Razor Wire Properties LLC

Re: Hillsboro Zoning Board of Adjustment Cease & Desist.

RE: Inspection of Existing Slab
For Proposed Manufactured Housing
24 Autumn Road
Hillsborough, New Hampshire

Figure 600-3 Slab Specifications

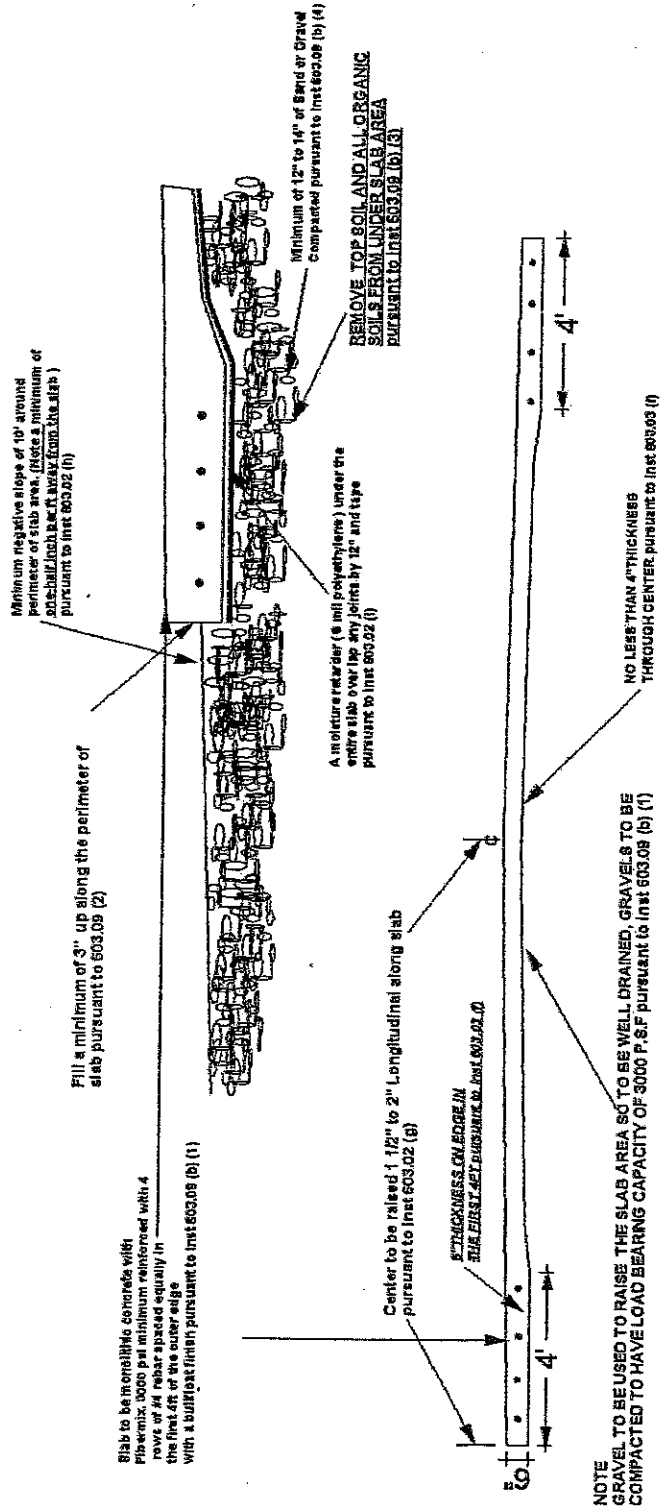
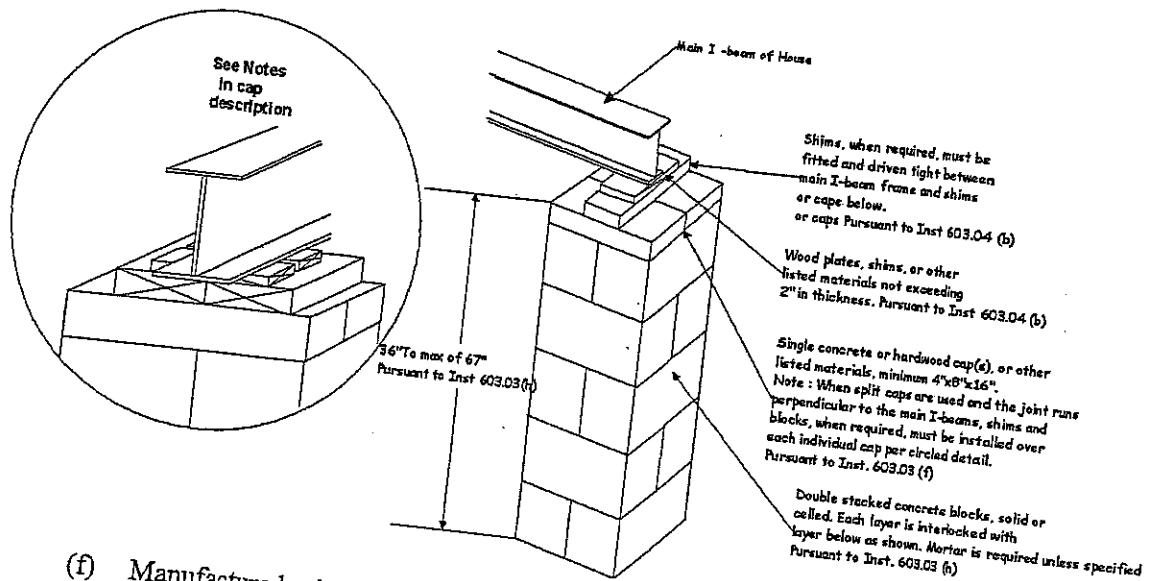
The information pertaining to the slab that was provided specified that the slab is 14'x52' with a 4' wide, 6" thick perimeter. The interior of the slab is 4" thick. The 6"x4' perimeter has steel reinforcement equal to (4) # 4 bars evenly spaced. The concrete used for the slab is a fiber reinforced mix with a 28-day compressive strength of 3,000 psi. A 6 mil polyethylene plastic moisture retarder was installed under the concrete slab.

Upon reviewing the NH Manufactured Housing Installation Standards Board, Chapter Inst. 600 and specifically Figure 600-3 - Slab Specifications, it appears as though slab was installed per the State of New Hampshire standards for Manufactured Housing. The slab is acceptable as long as it was constructed to be in 100% compliance with the installation standards provided in the NH Manufactured Housing Installation Standards Board.
